US DEPARTMENT OF ENERGY
HANFORD WASTE VITRIFICATION PLANT

DESIGN CHANGE NOTICE

DCN - 0100 | REV 1 | PAGE 1 OF 18

DCN TITLE: THIS DCN-0100 SUPERSEDES "DCN-0096" & "DCN-0096 REV 1"

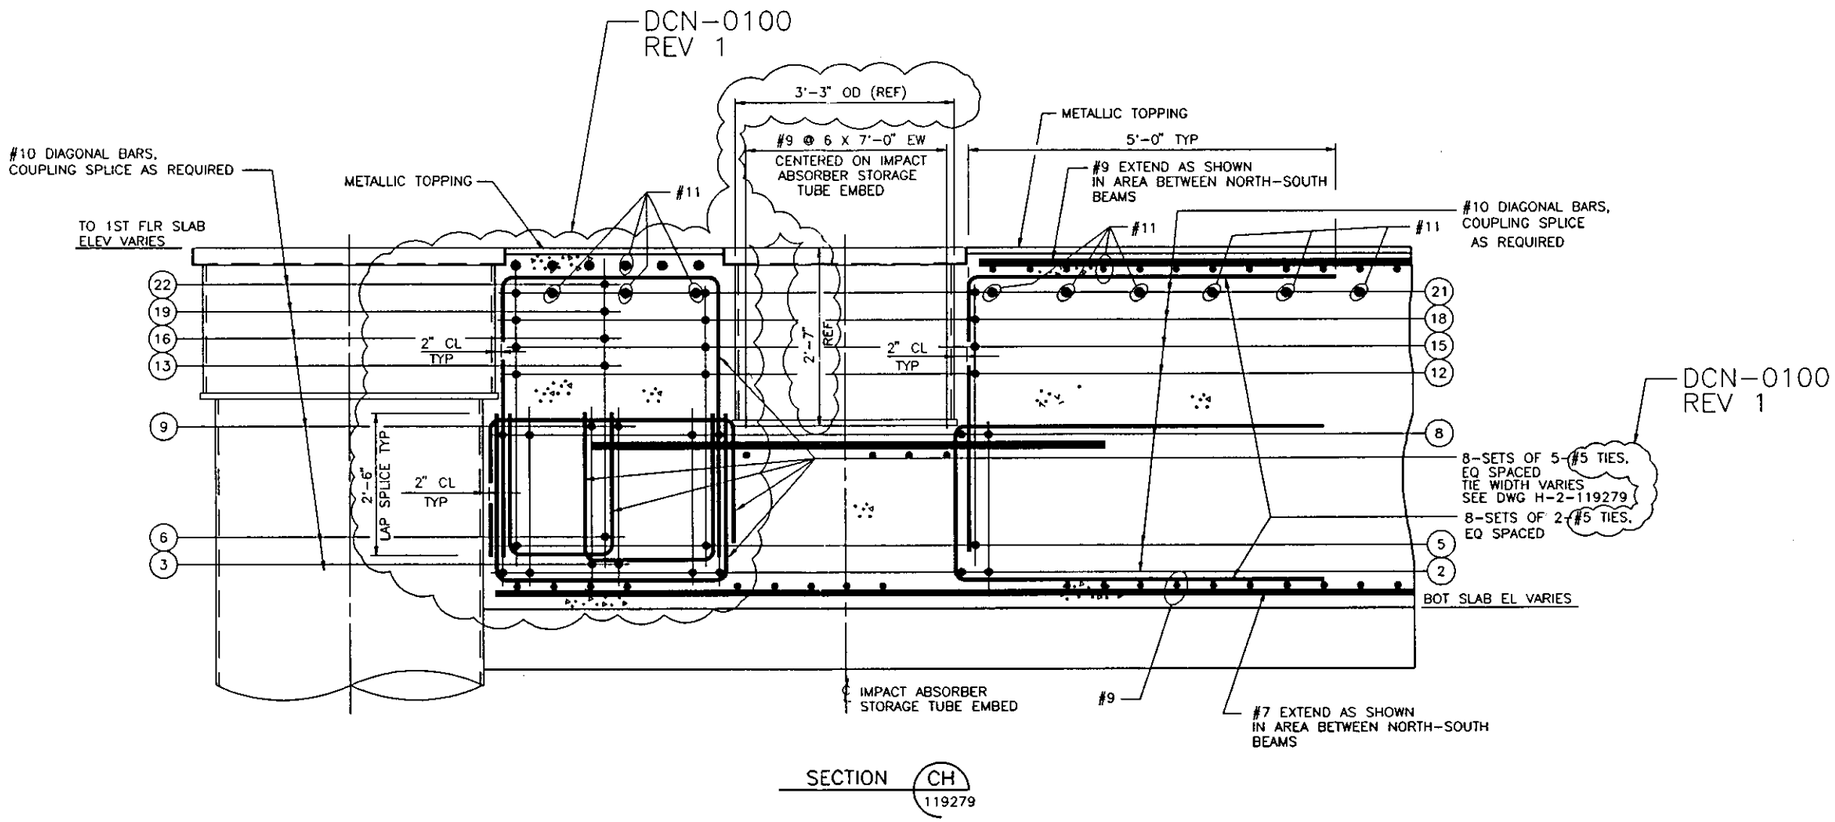
FLUOR DANIEL	U.S. DEPARTMENT OF ENERGY HANFORD WASTE VITRIFICATION PLANT	DESIGN CHANGE NOTICE
DESCRIPTION OF CHANGE REMOVE HOLD HWVP-FD-372. REVISE REINFORCING TIES. REVISE IMPACT ABSORBER STORAGE TUBE EMBED DIMENSIONS.		BASE DOC. NO. H-2-119280 SHT/PG. 3 REV. 1 CR NO. CR-HWVP-1025 DISCIPLINE: STRUCTURAL/DCN0096R
PREPARED BY: Armando Villegas	DATE: 9/28/93	DCN - 0100 REV. 1 PAGE 11
DISCIPLINE ENGINEER: Robert J. Lindberg	DATE: 9-28-93

DETAIL 98 / 119276

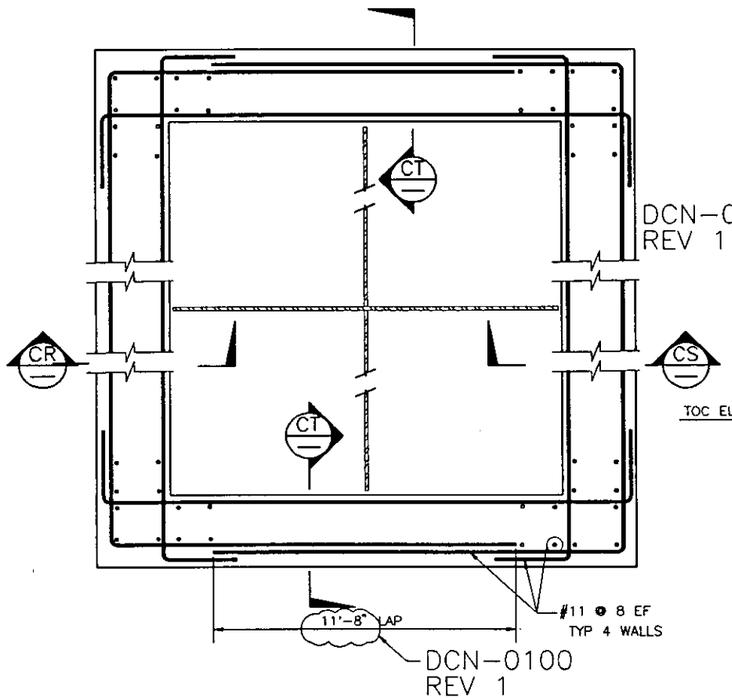
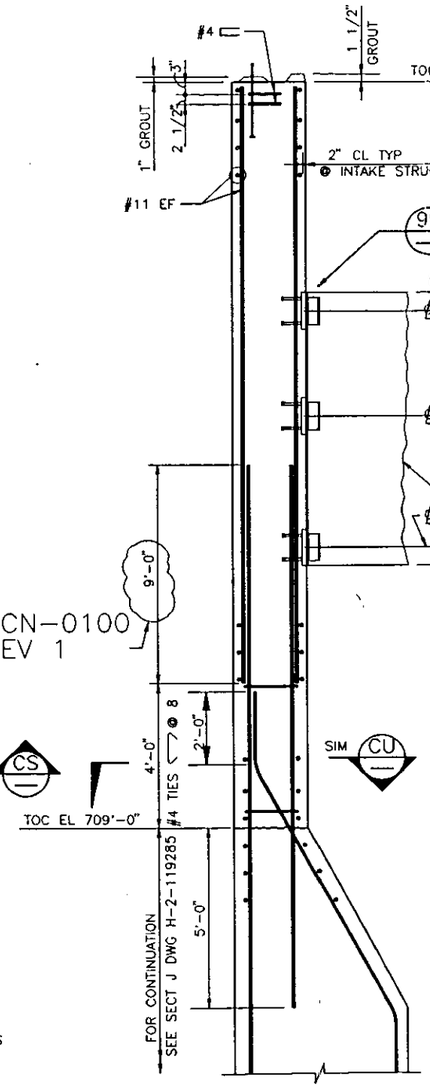
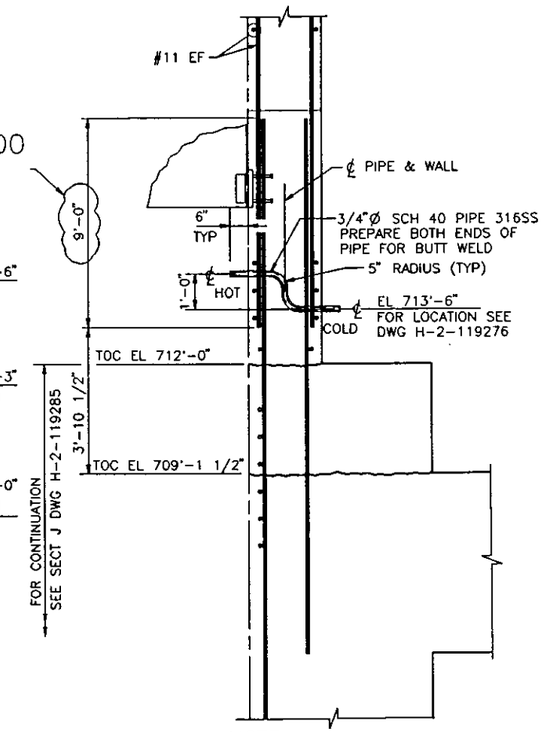
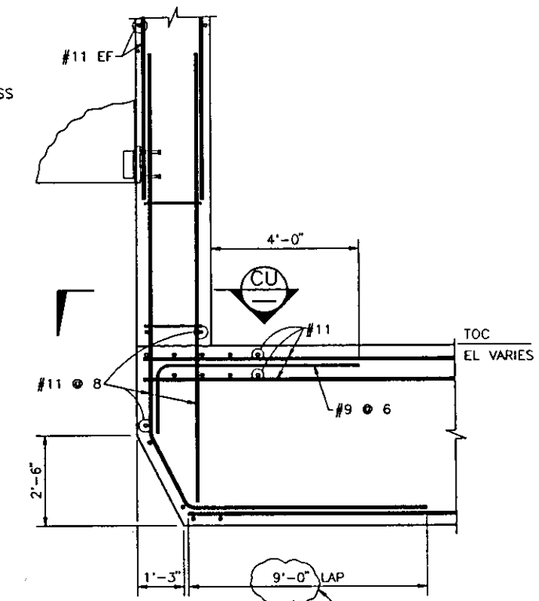
FLUOR DANIEL	U.S. DEPARTMENT OF ENERGY HANFORD WASTE VITRIFICATION PLANT	DESIGN CHANGE NOTICE
DESCRIPTION OF CHANGE REMOVE HOLD HWVP-FD-372. REVISE REINFORCING LAPS.		BASE DOC. NO. H-2-119280 SHT/PG. 3 REV. 1 CR NO. CR-HWVP-1025 DISCIPLINE: STRUCTURAL/DCN0096S
PREPARED BY: Armando Villegas	DATE: 9/28/93	DCN - 0100 / REV. 1 / PAGE 12
DISCIPLINE ENGINEER: Robert D. Hubers	DATE: 9/28/93

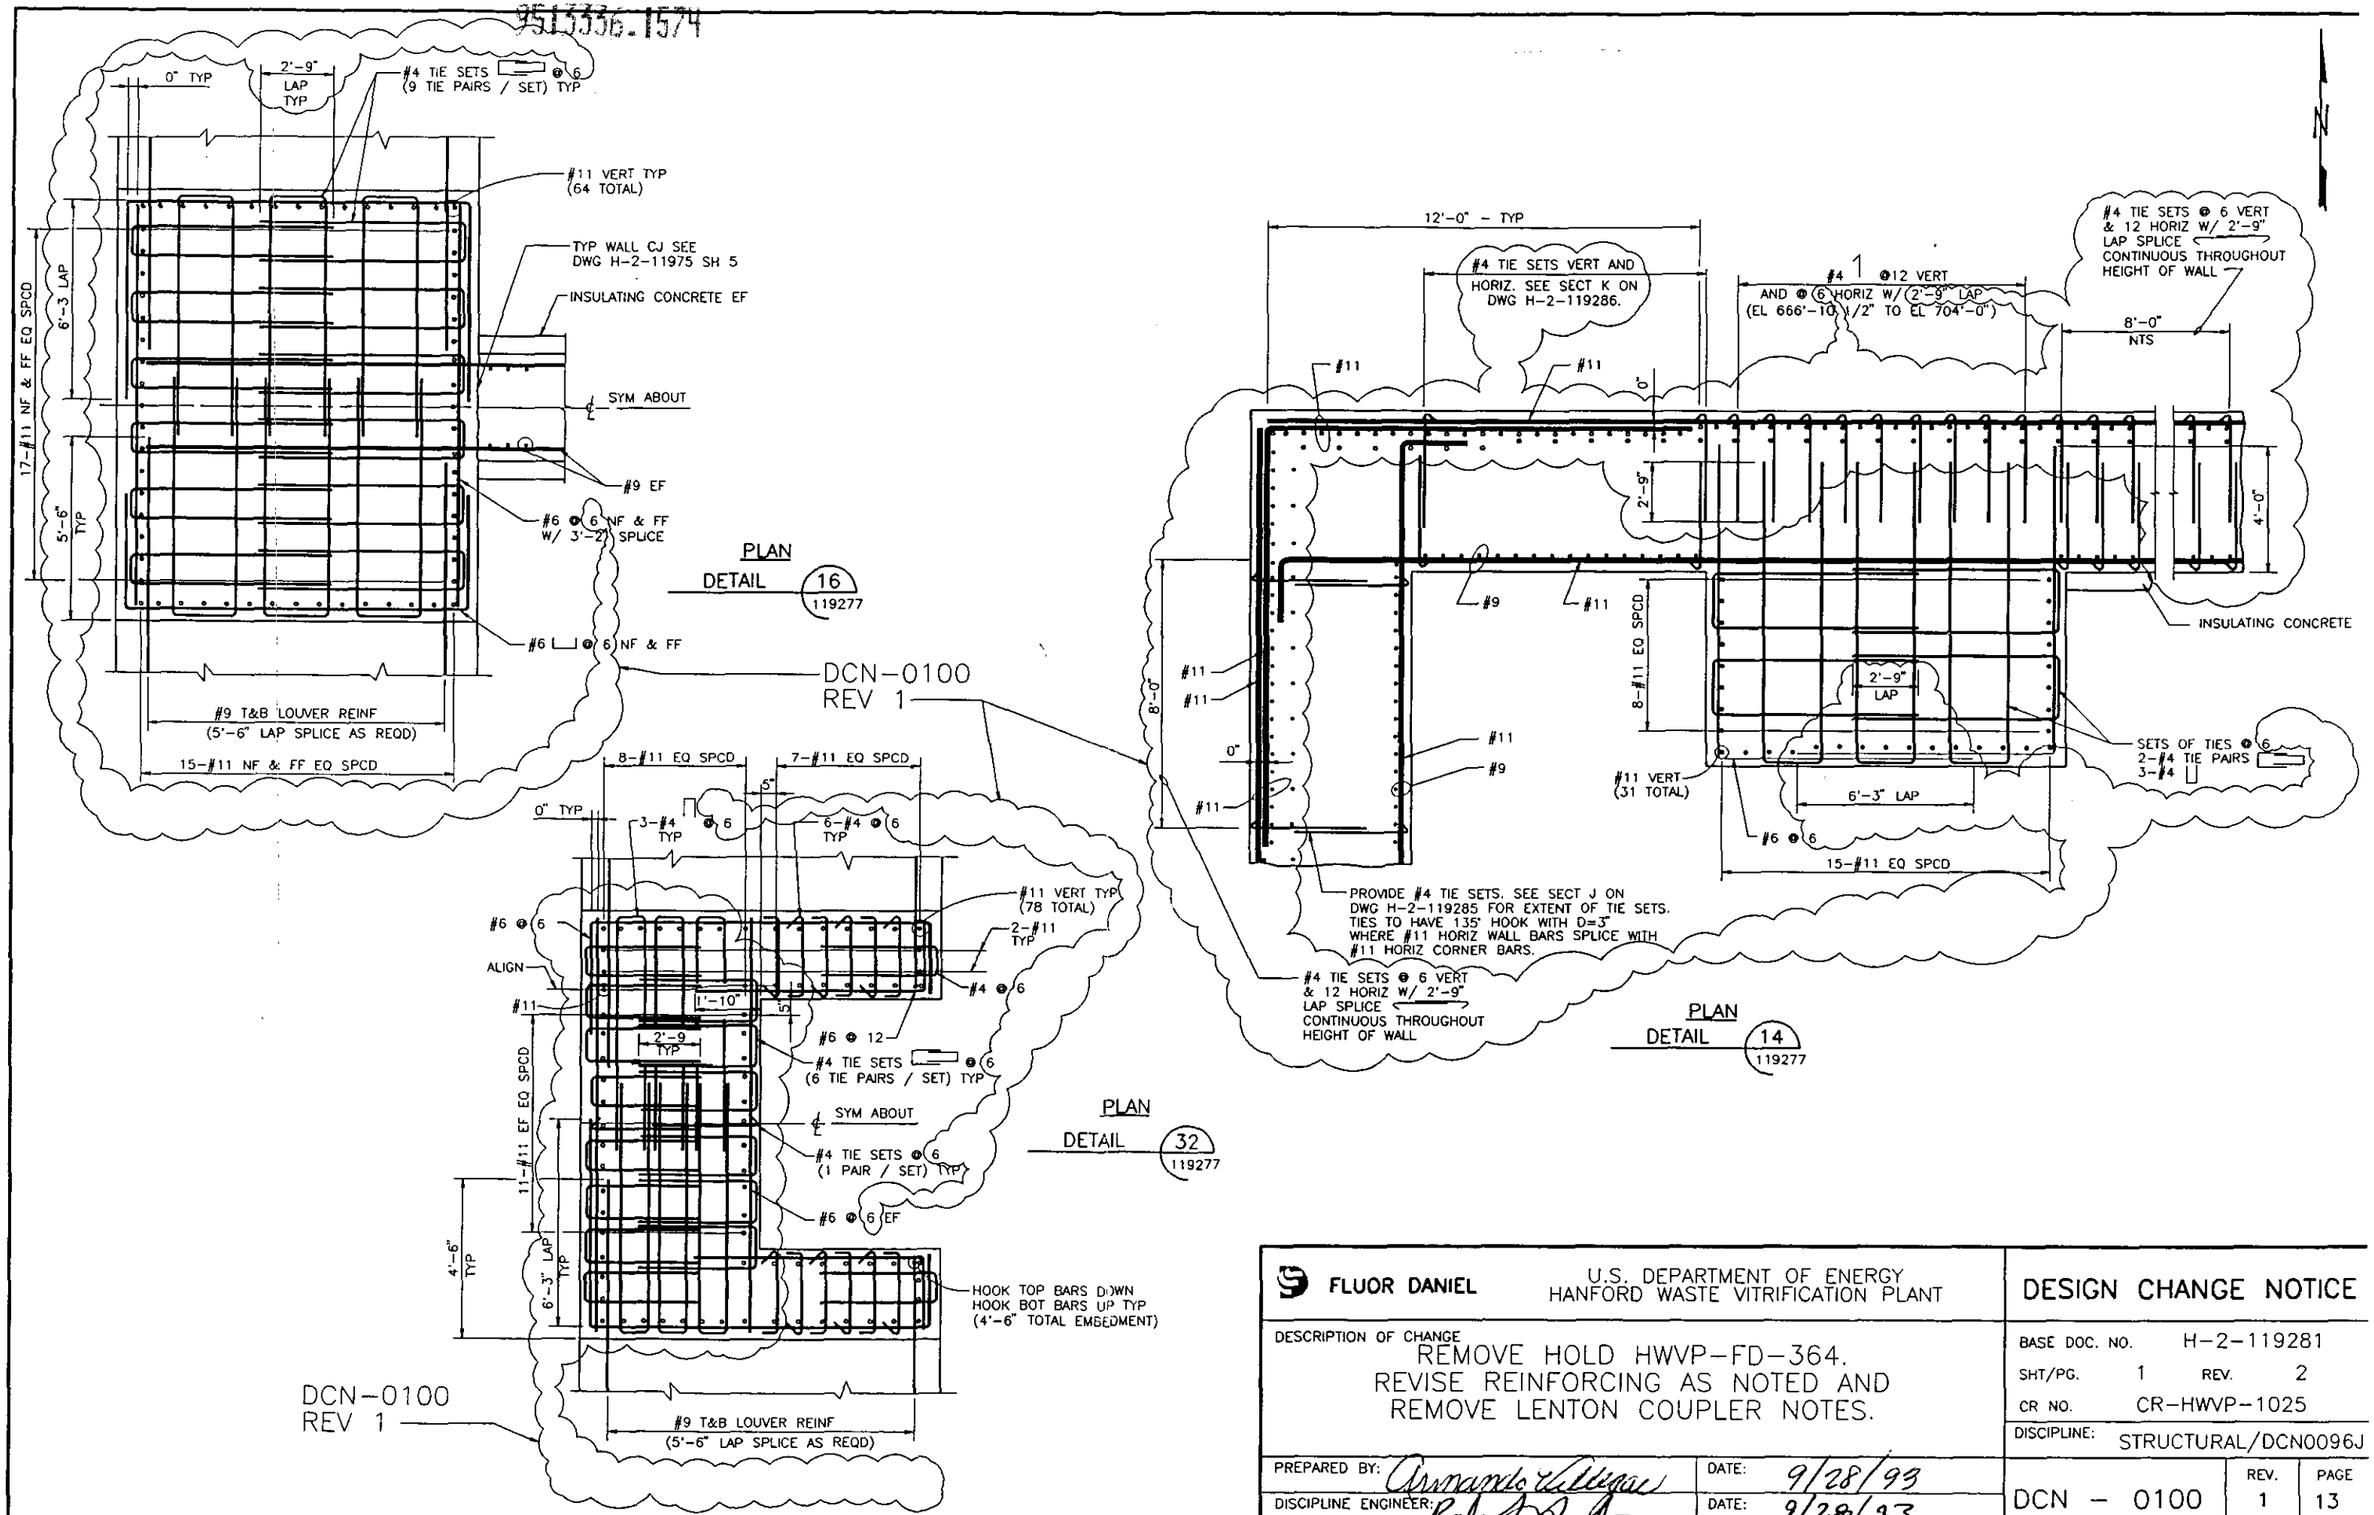
FLUOR DANIEL	U.S. DEPARTMENT OF ENERGY HANFORD WASTE VITRIFICATION PLANT	DESIGN CHANGE NOTICE
DESCRIPTION OF CHANGE REMOVE HOLD HWVP-FD-364. REVISE REINFORCING AS NOTED AND REMOVE LENTON COUPLER NOTES.		BASE DOC. NO. H-2-119281 SHT/PG. 1 REV. 2 CR NO. CR-HWVP-1025 DISCIPLINE: STRUCTURAL/DCN0096J
PREPARED BY: Armando Villegas	DATE: 9/28/93	DCN - 0100 REV. 1 PAGE 13
DISCIPLINE ENGINEER: Rolo J. Dubon	DATE: 9/28/93

DETAIL 15 / 119277

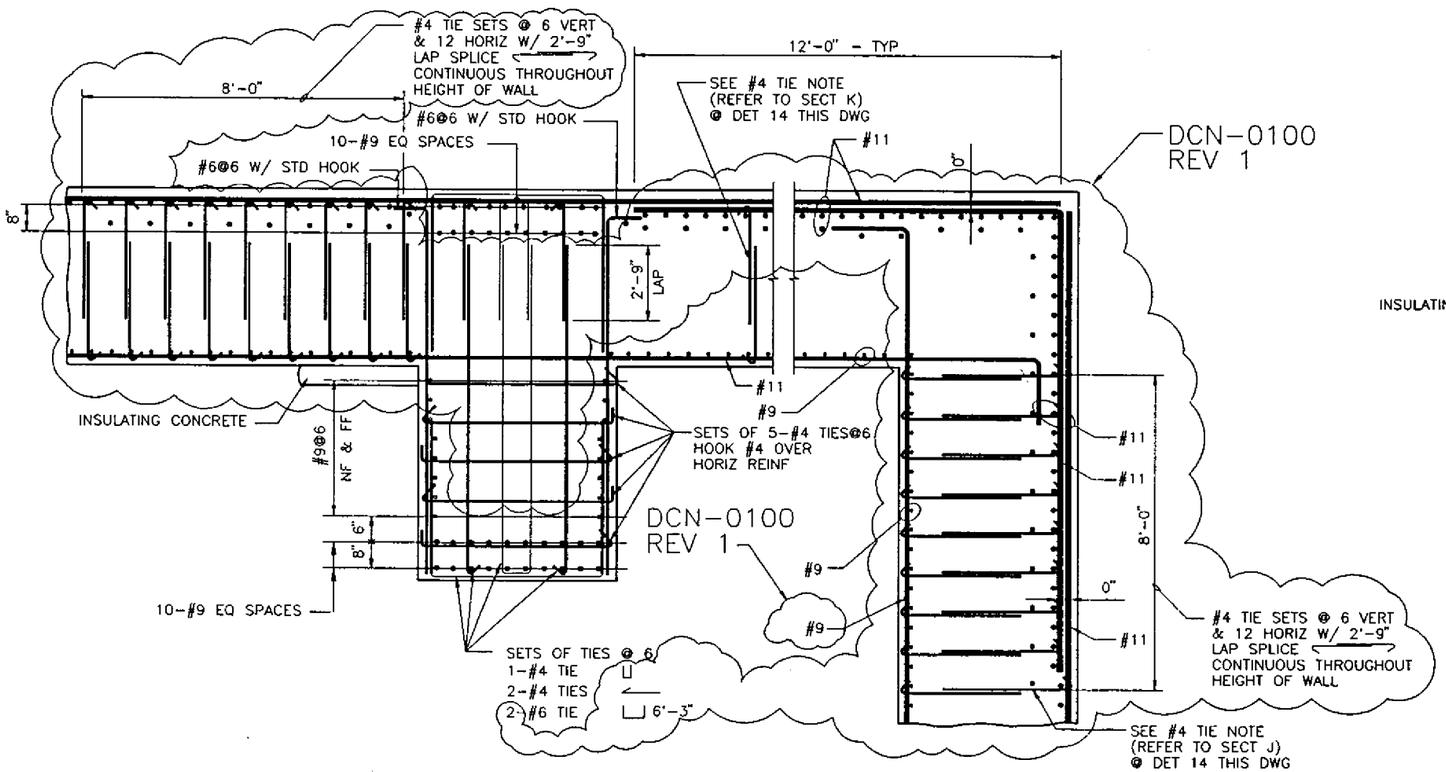
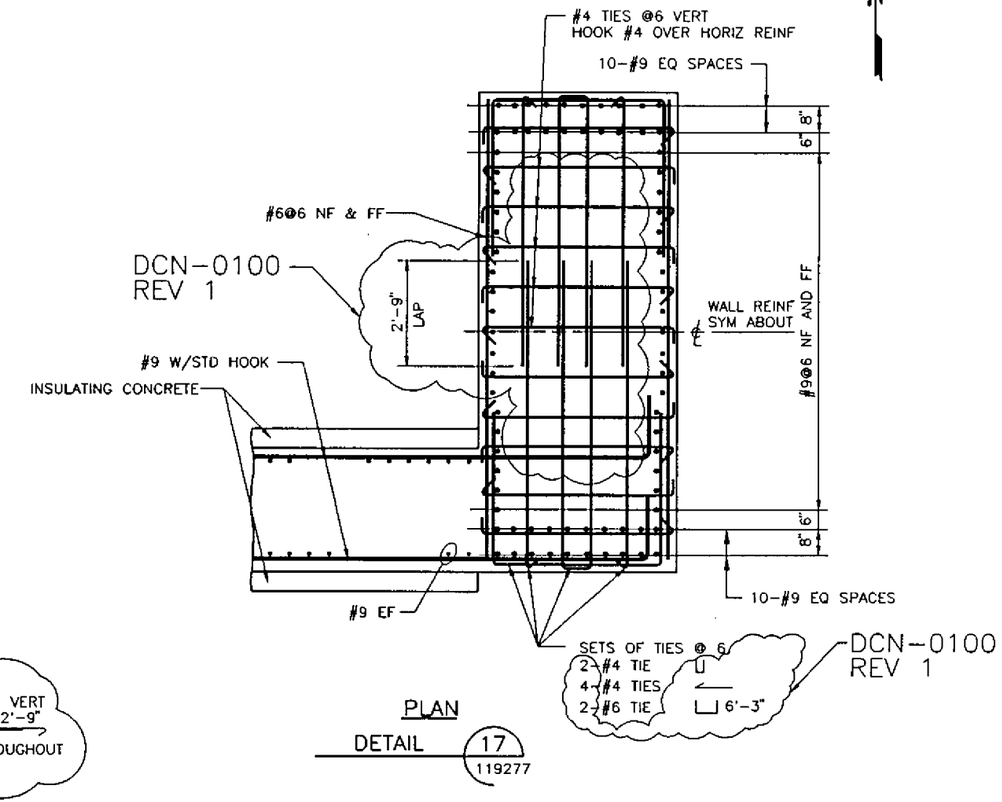
REVISE HORIZONTAL REINFORCING BAR AS INDICATED WITH "DCN-0100 REV 1" ON PAGE 14.

FLUOR DANIEL — U.S. DEPARTMENT OF ENERGY, HANFORD WASTE VITRIFICATION PLANT		DESIGN CHANGE NOTICE
DESCRIPTION OF CHANGE: REMOVE HOLD HWVP-FD-364. REVISE REINFORCING AS NOTED.		BASE DOC. NO. H-2-119281; SHT/PG. 1; REV. 2; CR NO. CR-HWVP-1025; DISCIPLINE: STRUCTURAL/DCN0096K
PREPARED BY: Armando Villegas	DATE: 9/28/93	DCN - 0100 — REV. 1 — PAGE 14
DISCIPLINE ENGINEER: Robert J. Smith	DATE: 9/28/93

SECTION CP 119279

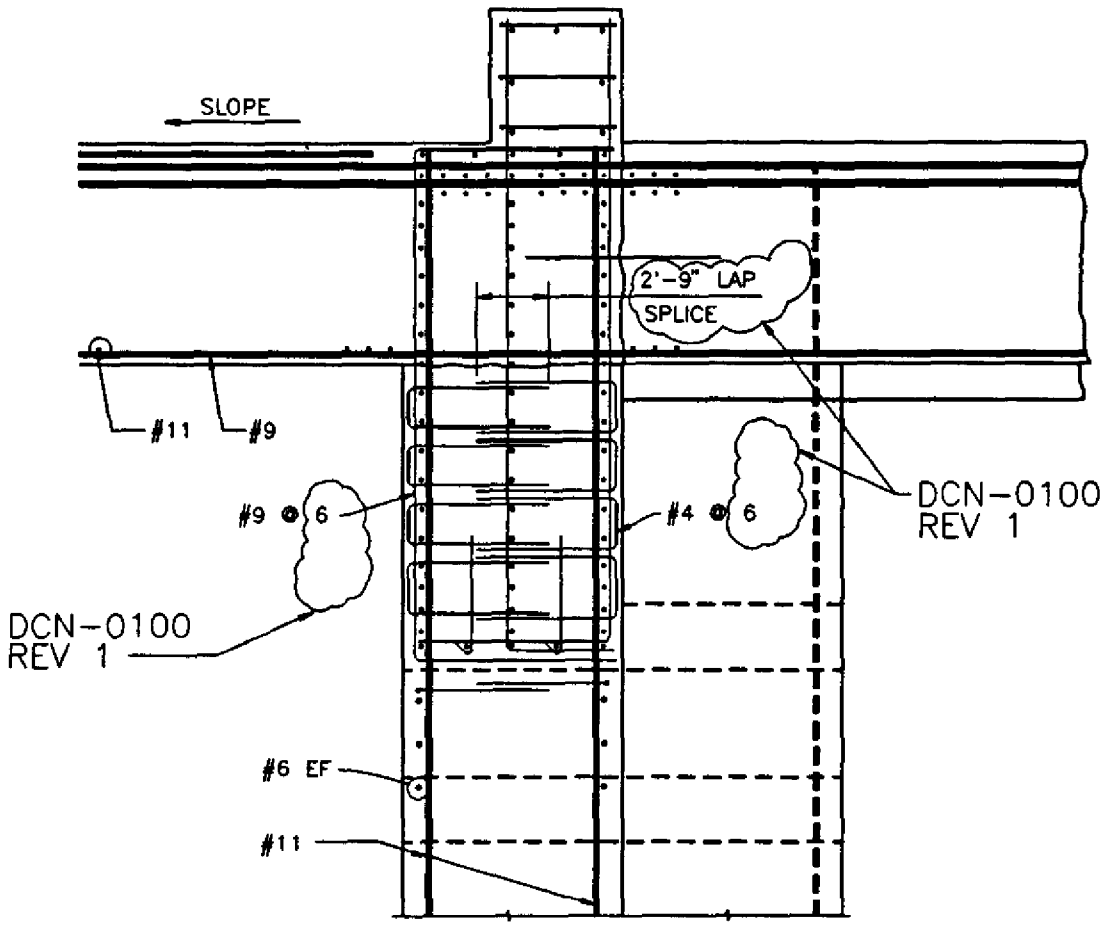
FLUOR DANIEL	U.S. DEPARTMENT OF ENERGY HANFORD WASTE VITRIFICATION PLANT	DESIGN CHANGE NOTICE
DESCRIPTION OF CHANGE: REMOVE HOLD HWVP-FD-364. REVISE REINFORCING SPACING AND TIE LAP AS NOTED.		BASE DOC. NO. H-2-119281 SHT/PG. 2 REV. 0 CR NO. CR-HWVP-1025 DISCIPLINE: STRUCTURAL/DCN0096H
PREPARED BY: Amanda Gillegan	DATE: 9/28/93	DCN - 0100 REV. 1 PAGE 15
DISCIPLINE ENGINEER: [signature]	DATE: 9-28-93
